ADDENDUM #2

Reference: Building 5030 Dining Hall Remodel/Addition – Camp Williams
Utah National Guard – Riverton, Utah
DFCM Project No. 06296480

ADDENDUM #2

Utah National Guard
Bldg. 503 Mess Hall
Camp W.G. Williams, Utah

SHEET P101

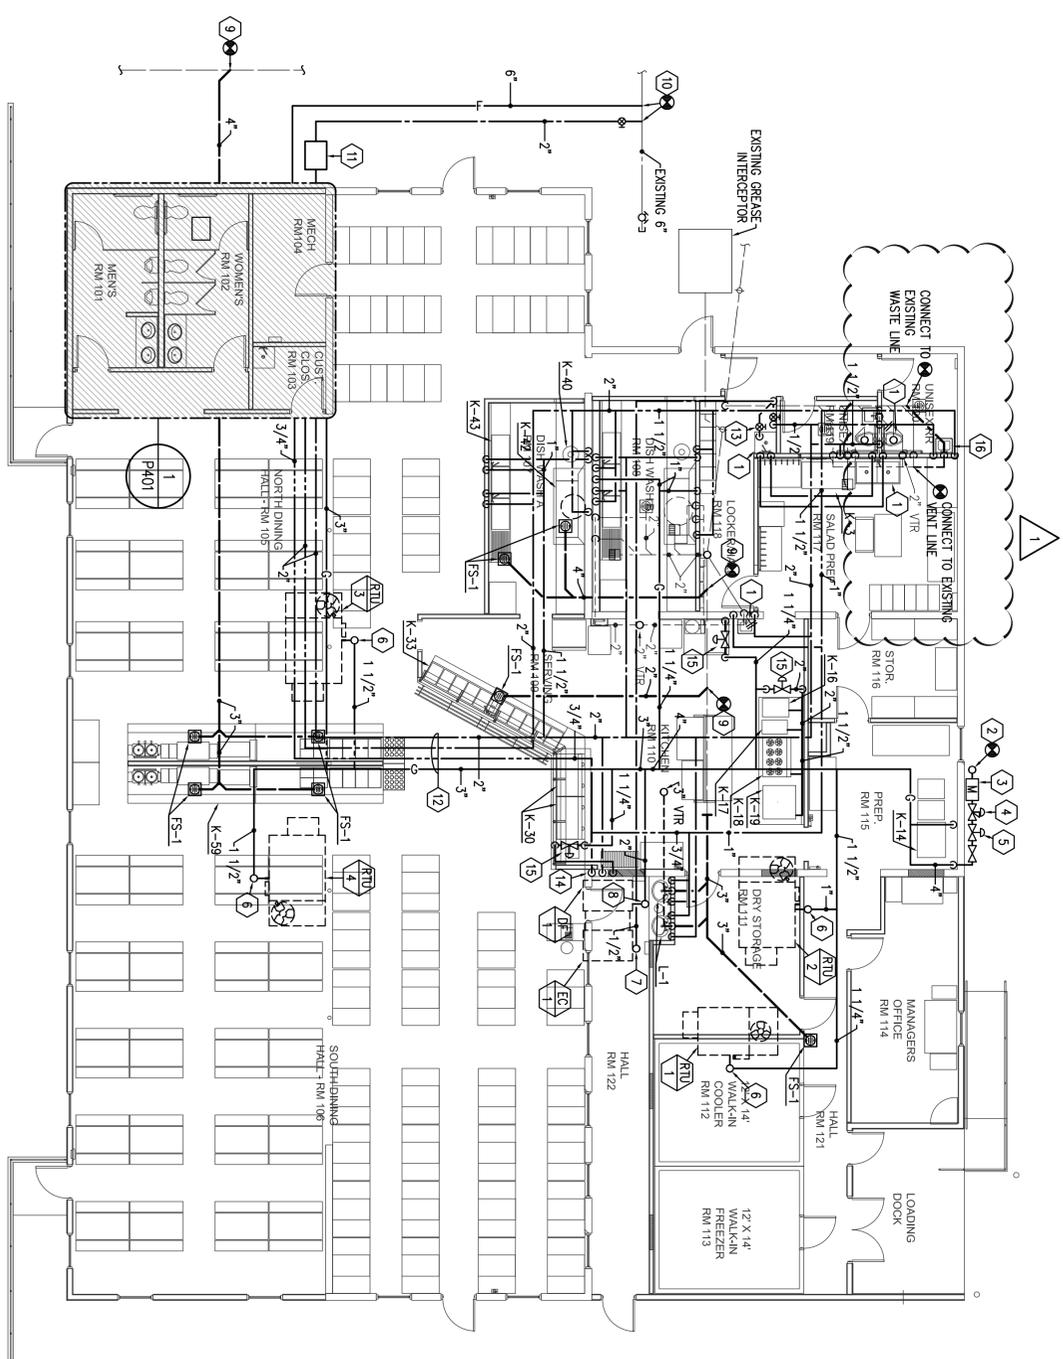
Item #1 Reinstall lavatory in Unisex RR 120 as indicated and replace sheet P101 with attached P101.

L11 ONE-LINE DIAGRAM NTS

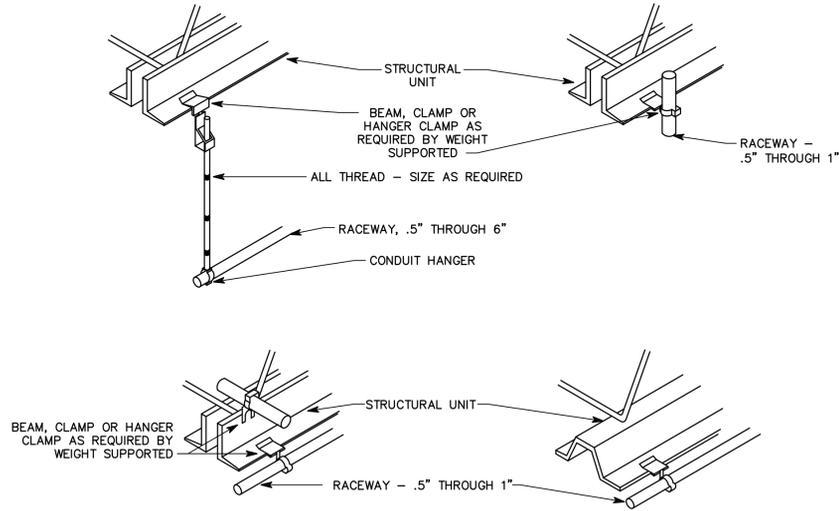
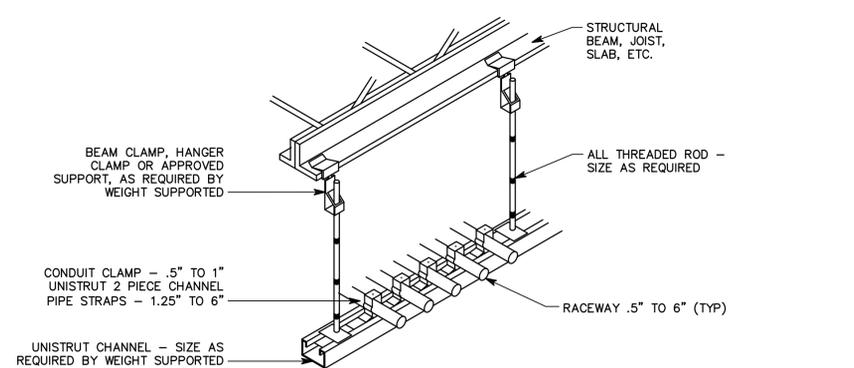
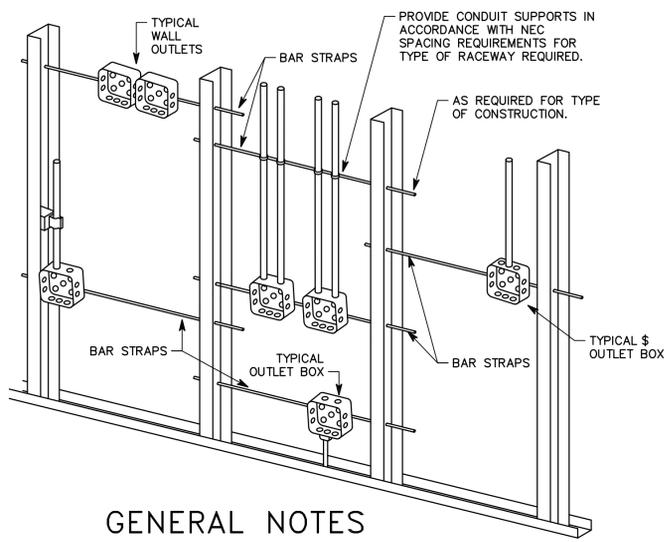
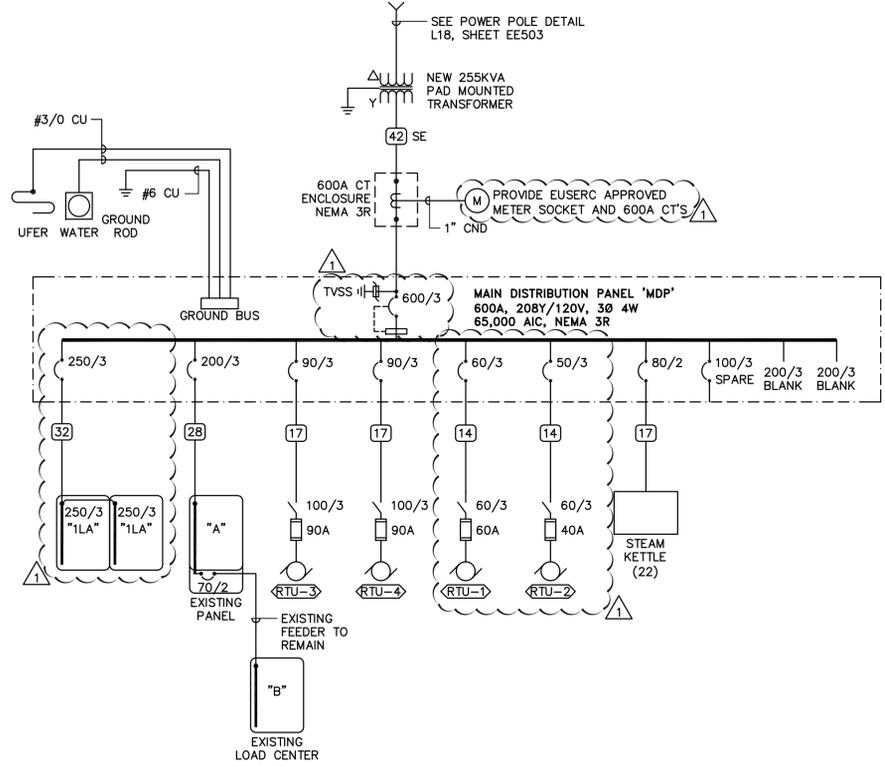
5. One-line diagram updated.
6. Main circuit breaker to be electronic trip.
7. Provide 120kA per phase TVSS on main service entrance gear.

L1 DEMOLITION PLAN
 SCALE: 3/16"=1'-0"

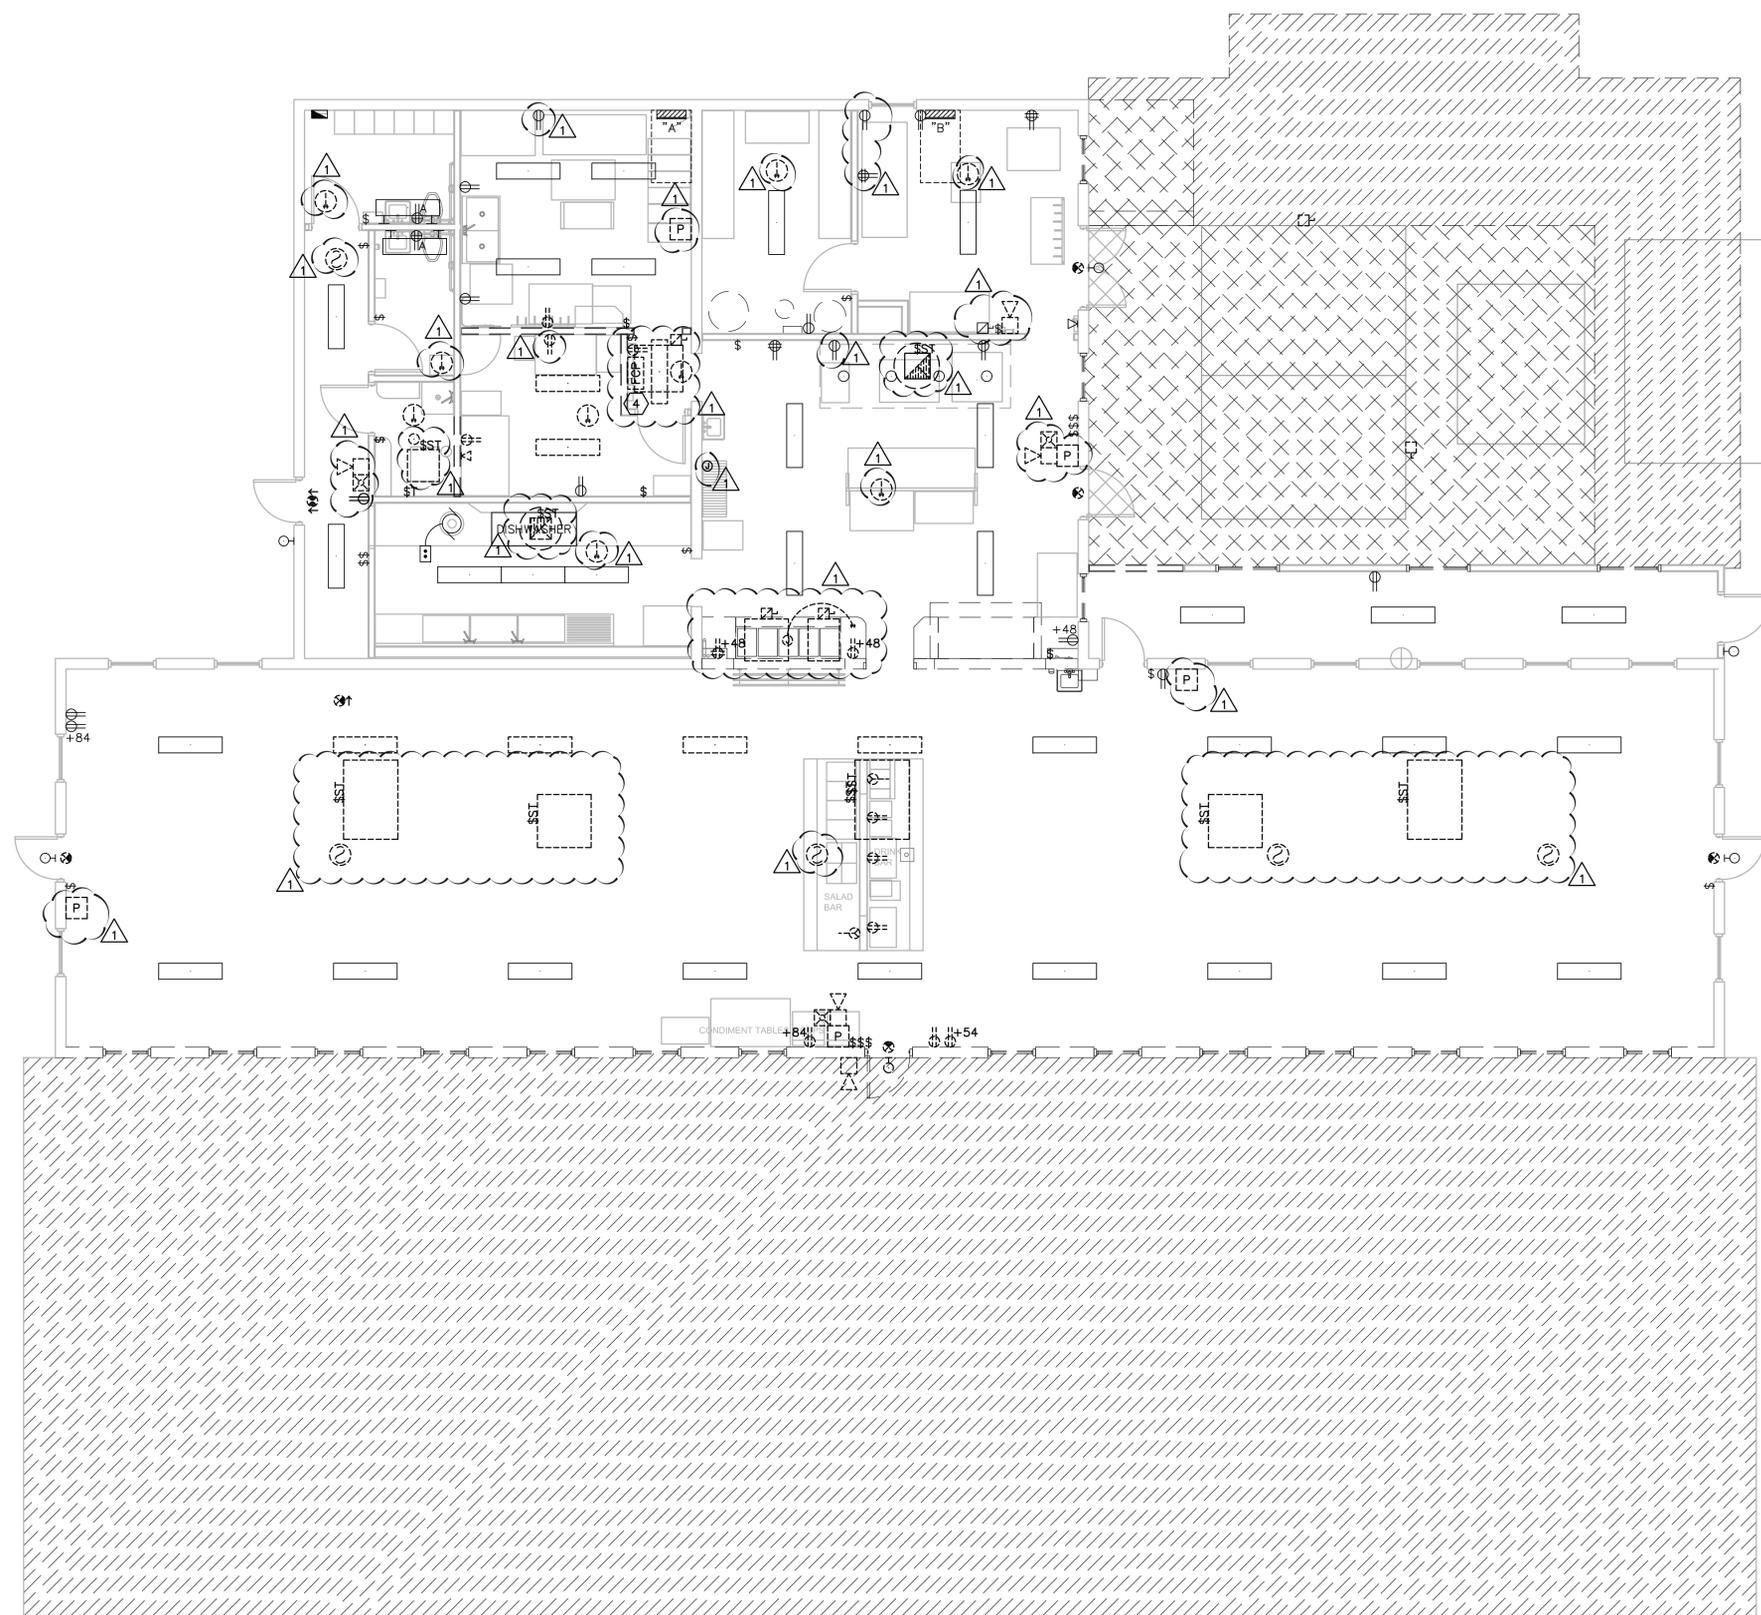
9. Remove all fire alarm equipment and devices
10. Mechanical equipment shown to be removed.

L1 POWER PLAN
 SCALE: 3/16"=1'-0"

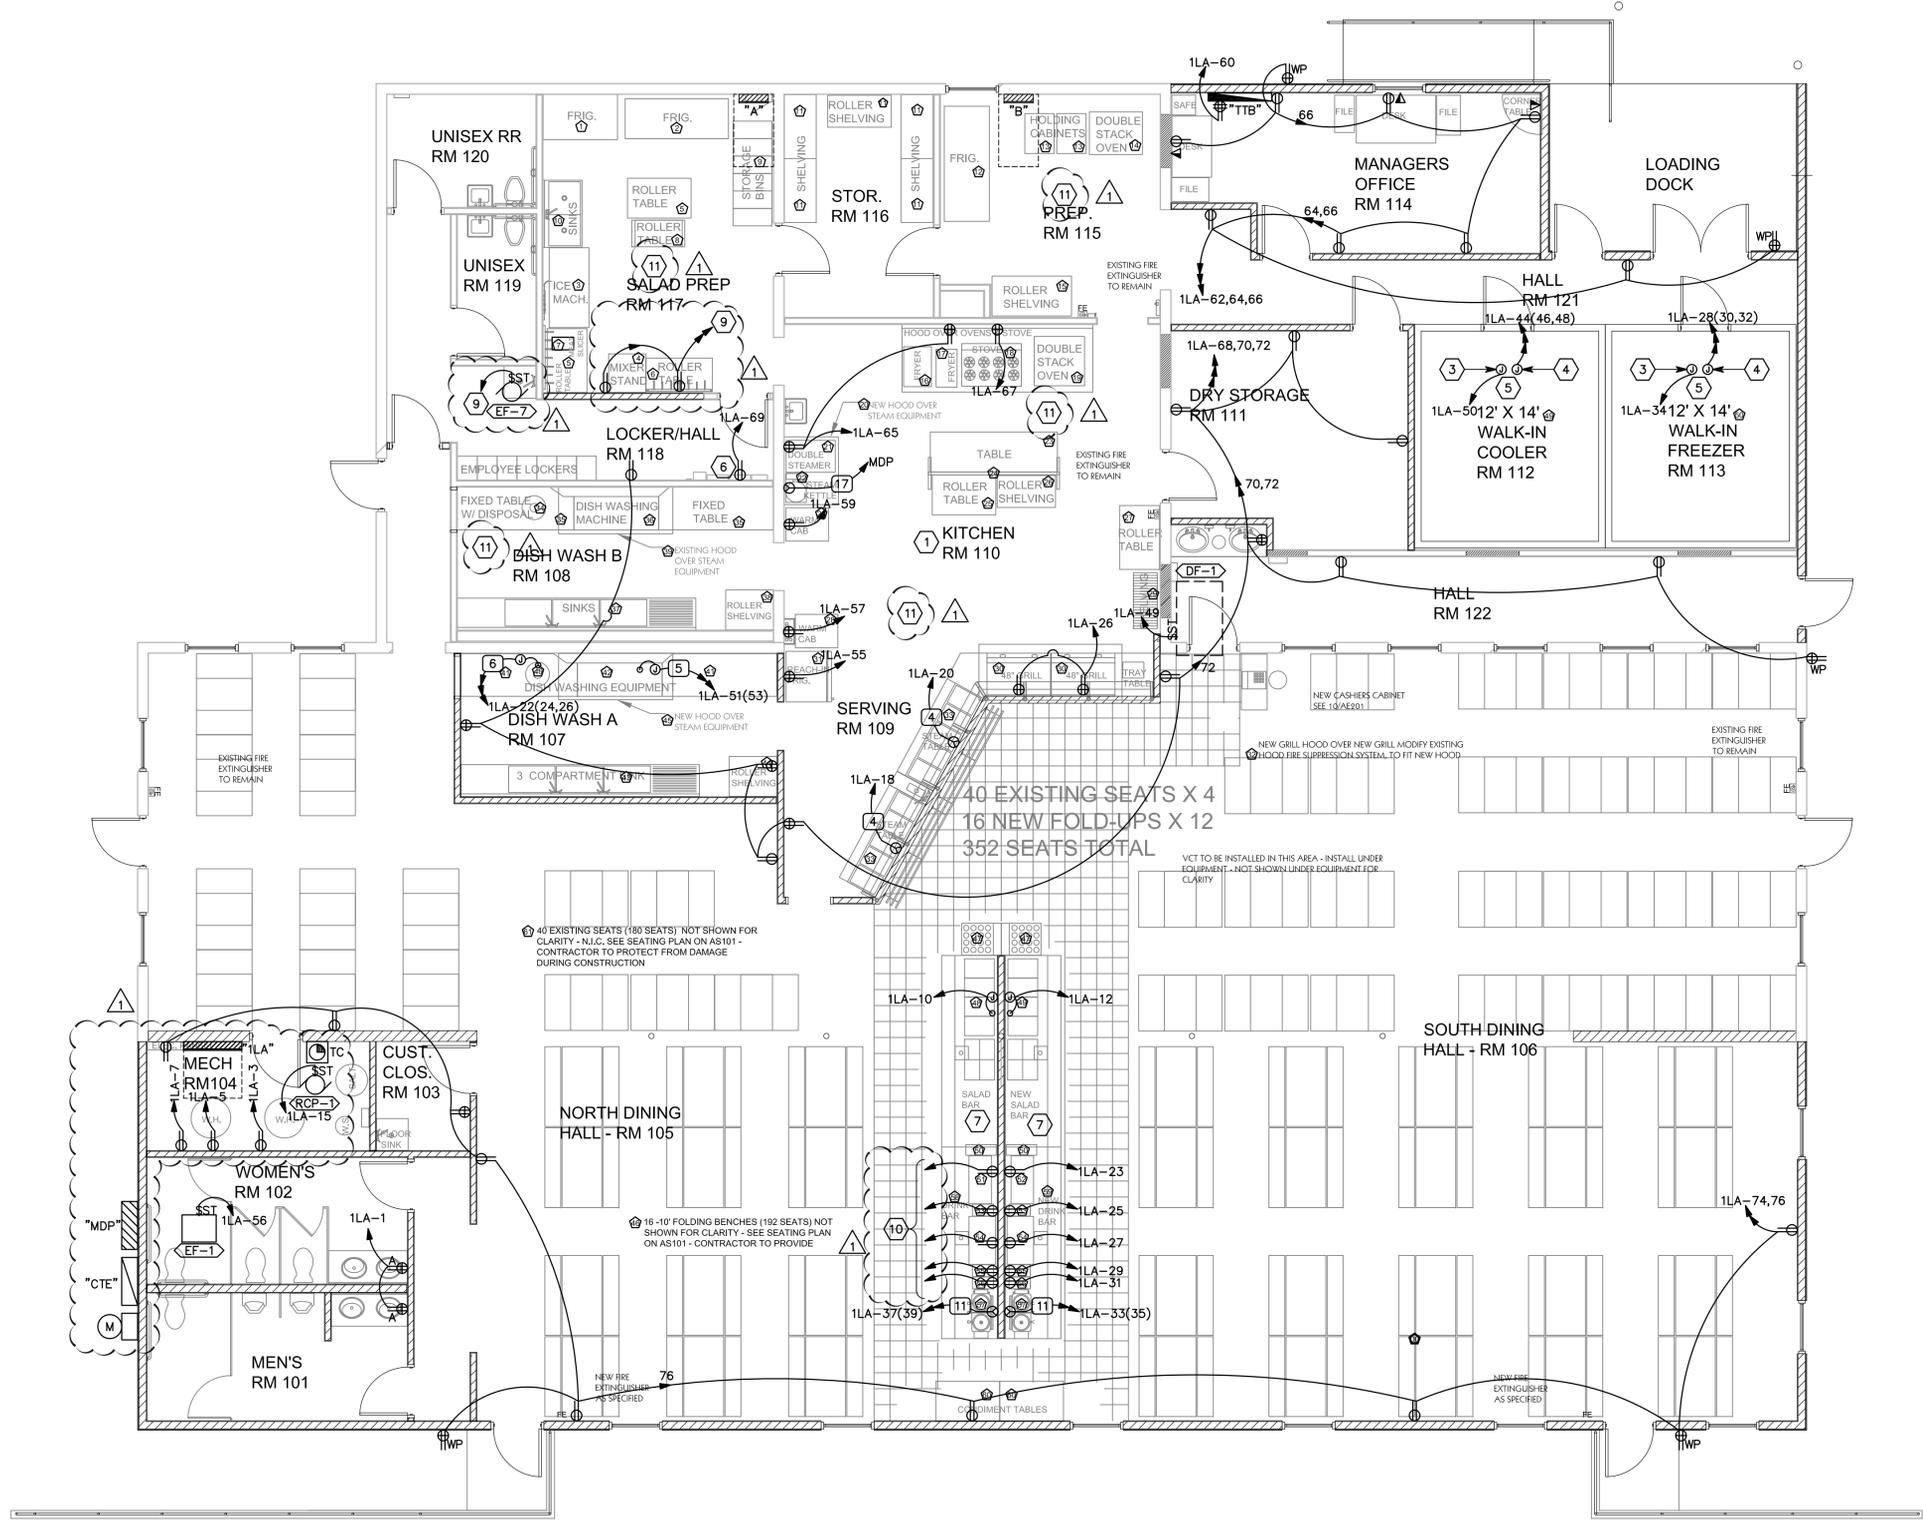
15. Outlets added in Salad Prep. Rm. 117

16. Existing equipment on the salad bar that is being relocated is to be circuited to their respective existing circuits in Panel "A".
17. Verify all newly shown and previously shown mechanical equipment and connection requirements. Various mechanical units have been modified/added.
18. Rooftop equipment to be shown on new sheet EP102
